RFP 2016-0009 - ADDENDUM 2

COLIGNY REDEVELOPMENT PROJECT

Town of Hilton Head Island, South Carolina

Date Issued: July 29, 2016

1 / M0.002 HEAT PUMP INSTALLATION DETAIL
NOT TO SCALE

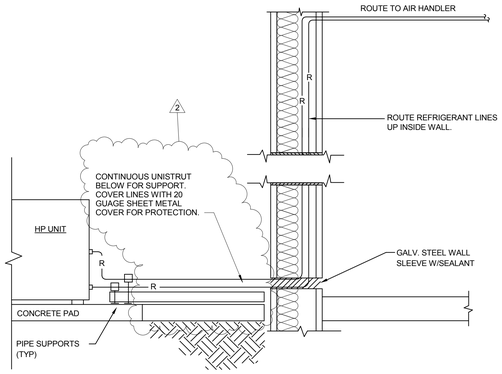
A. Detail 8/M0.002 Vertical AHU Installation Detail modified to reflect basis of design model.
B. Added support information to Detail 1/M0.002.

1 M1.101 CHILDREN'S MUSEUM HVAC PLAN
SCALE: 1/4" = 1'-0"

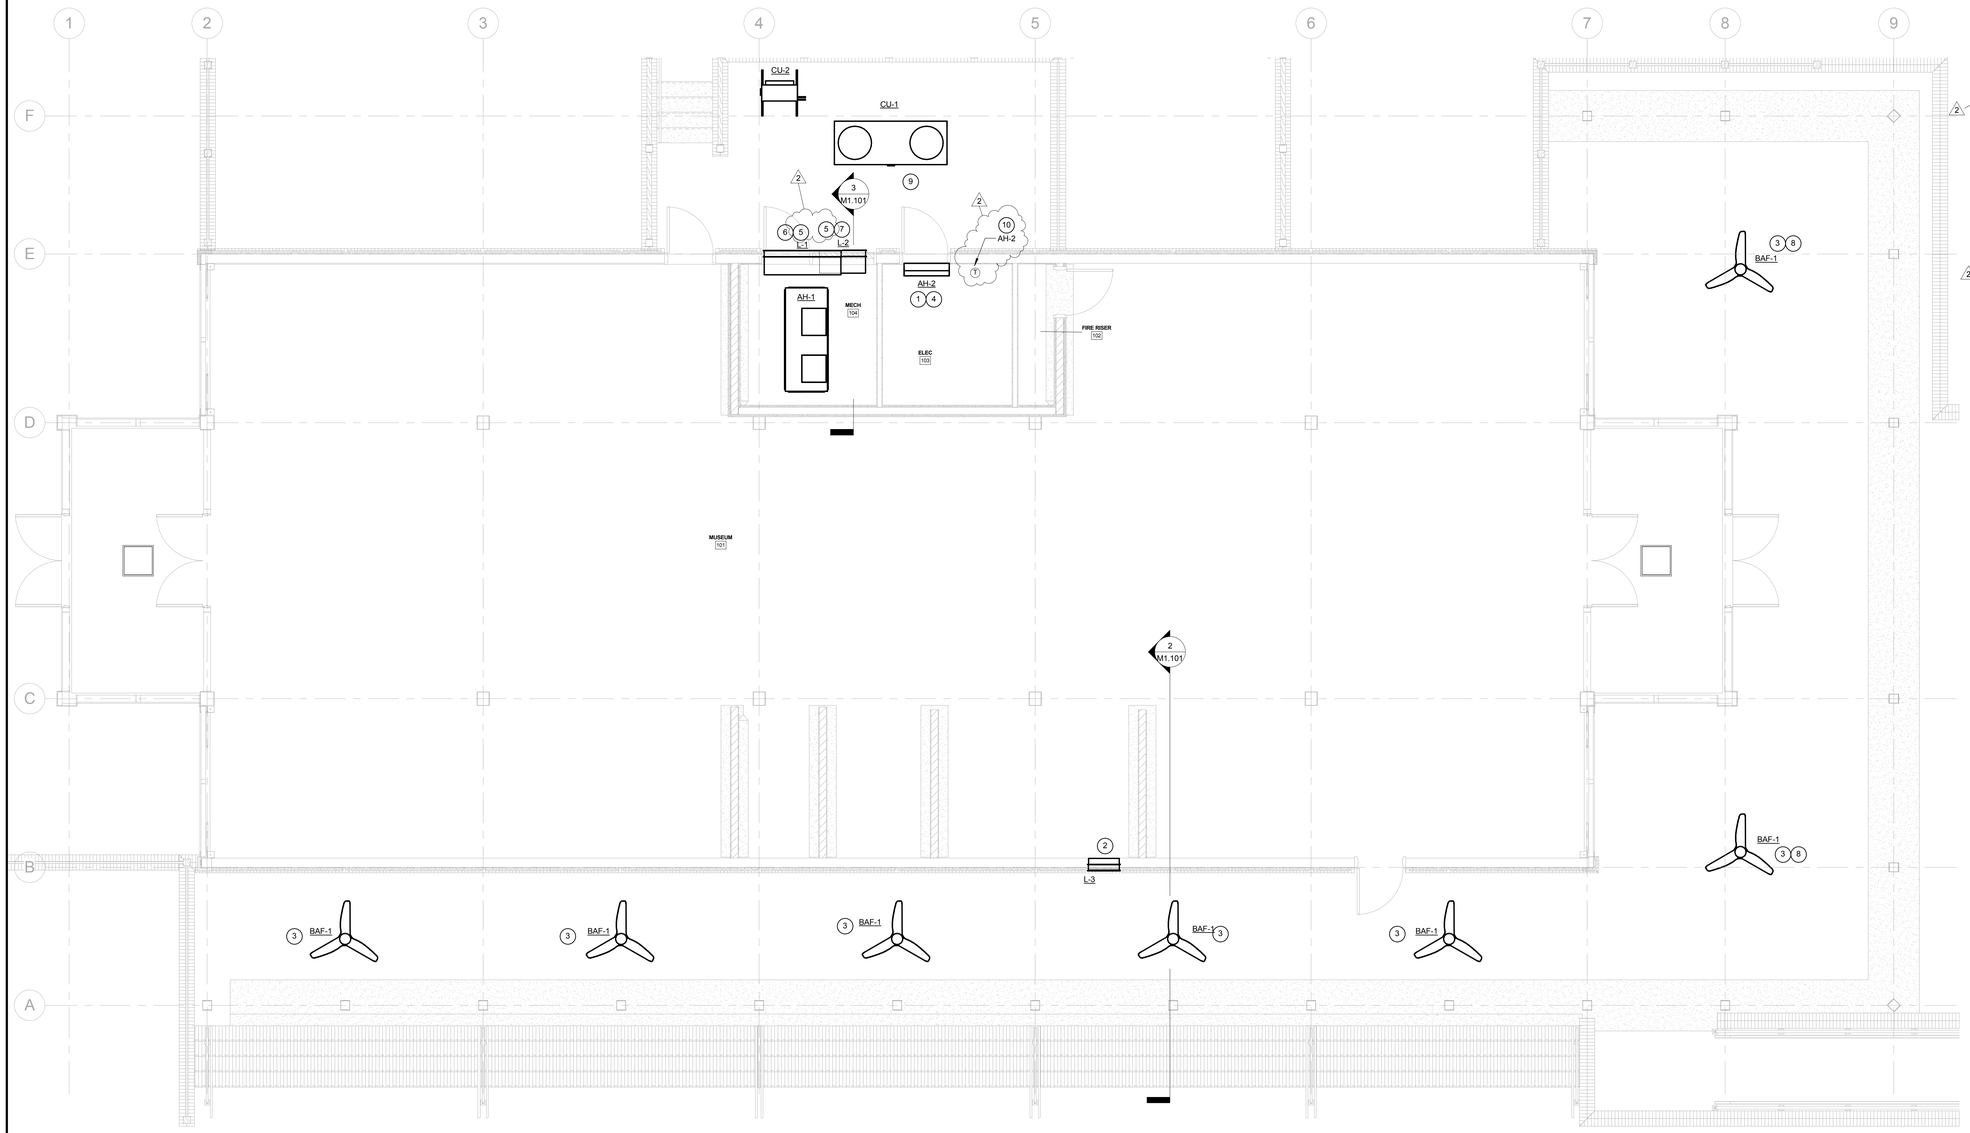
3.25 M1.101 – CHILDREN'S MUSEUM HVAC PLAN

A. Moved thermostat for AH-2 and added an isolation base.
B. Added ductwork plenums on resized exterior louvers.

1 M2.101 BATHROOM MAIN - HVAC PLAN
SCALE: 1/4" = 1'-0"

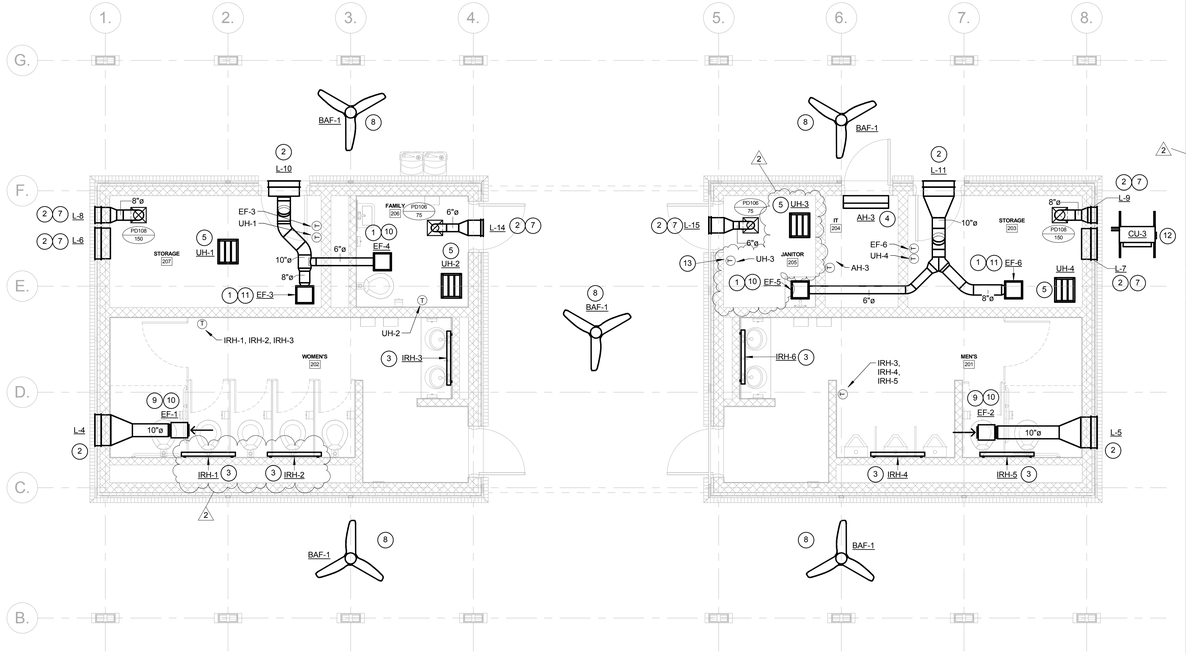
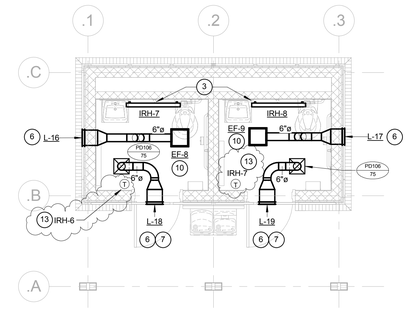
3.26 M2.101 – RESTROOM HVAC PLANS

A. UH-3 and associated thermostat have changed locations to avoid conflict with new location of water heater. Isolation base provided for new thermostat location.
B. Key Notes 8 and 12 modified.

1 M3.101 PAVILION HVAC PLAN
SCALE: 1/4" = 1'-0"

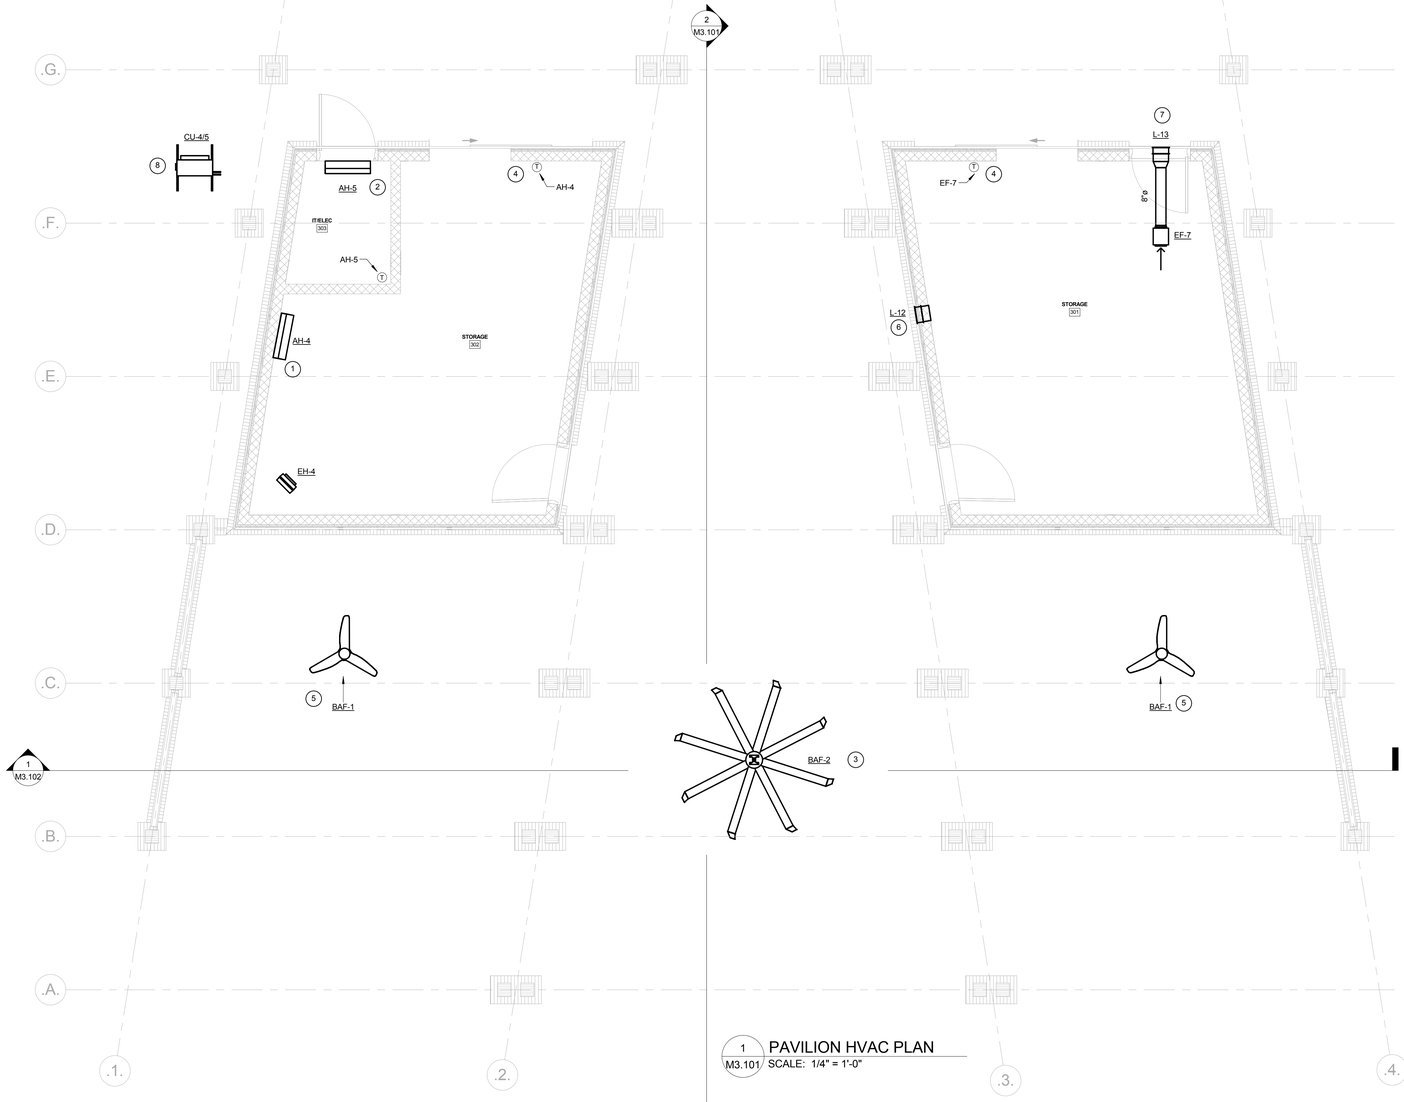
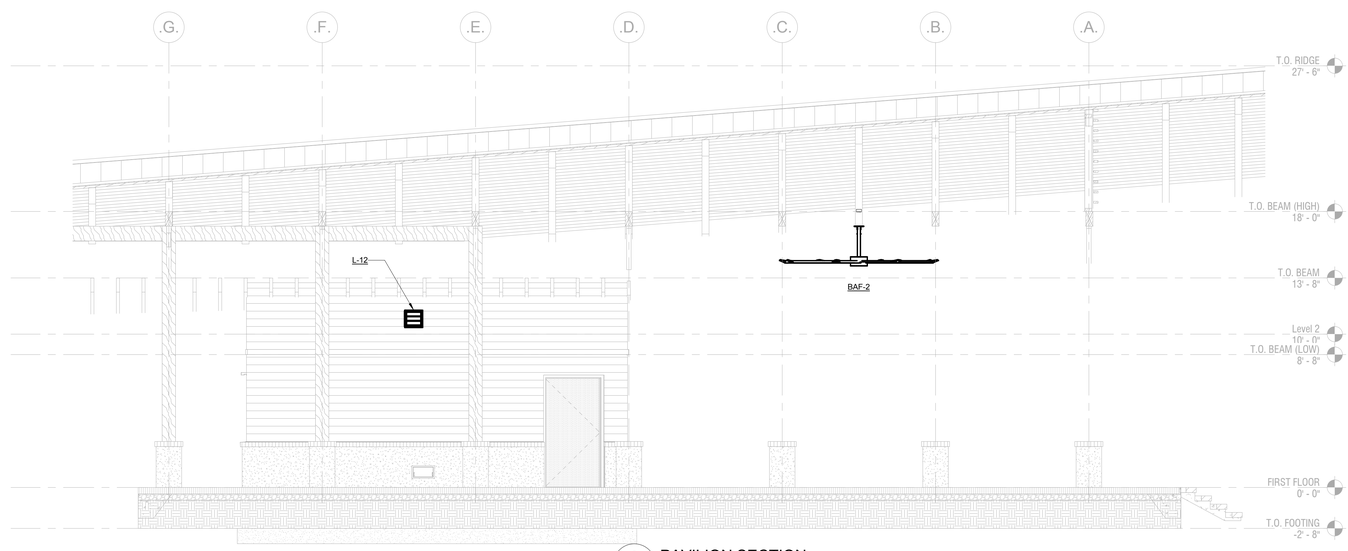
3.27 M3.01 – PAVILION HVAC PLAN AND SECTIONS

A. Key Notes 3, 5, and 8 modified.

2 / M3.102 POND PAVILION HVAC PLAN
SCALE: 1/4" = 1'-0"

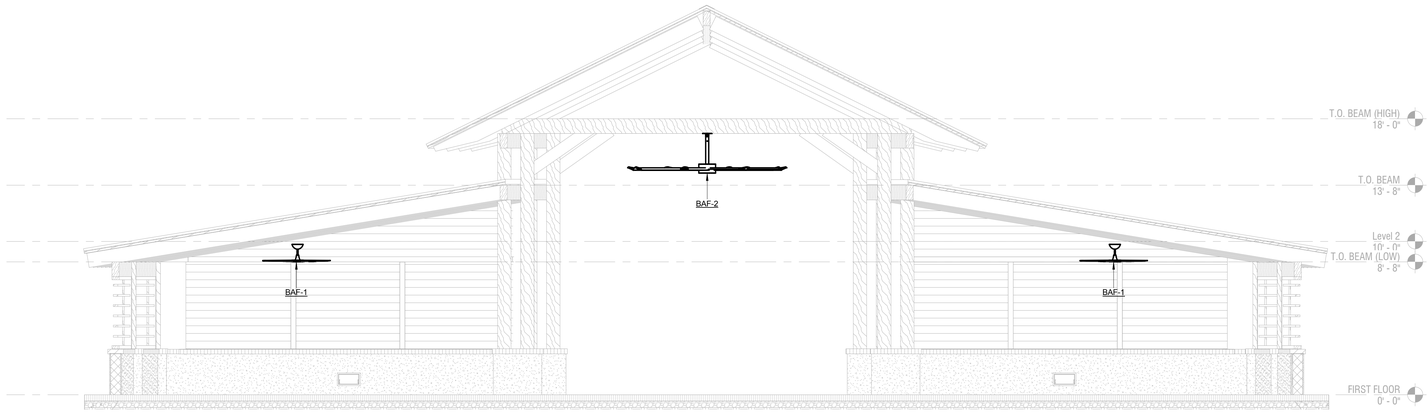
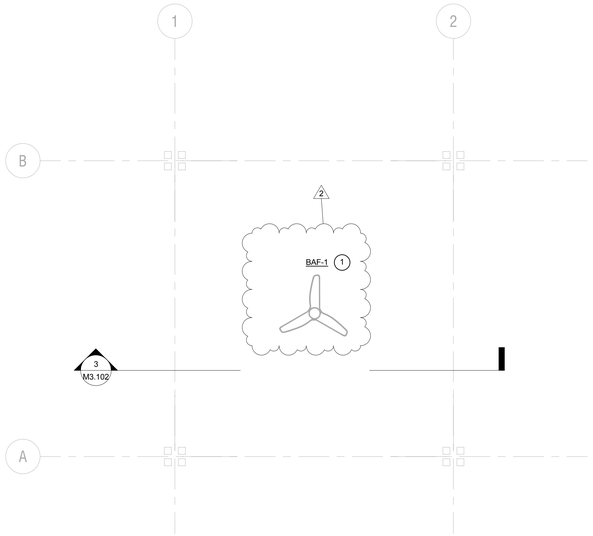
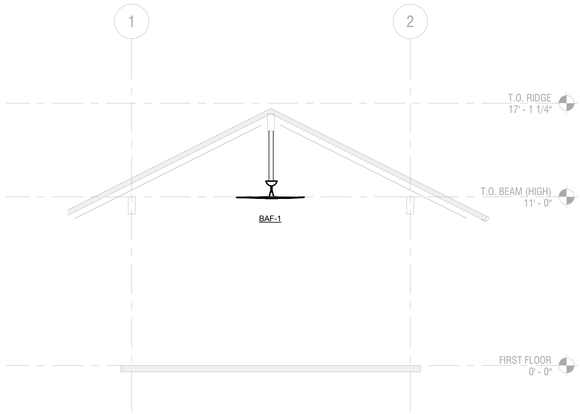
3.28 M3.102 – POND PAVILION HVAC PLAN AND SECTION

A. BAF-1 changed to a Haiku fan from an Essence fan. Key Note 1 reflects this change.
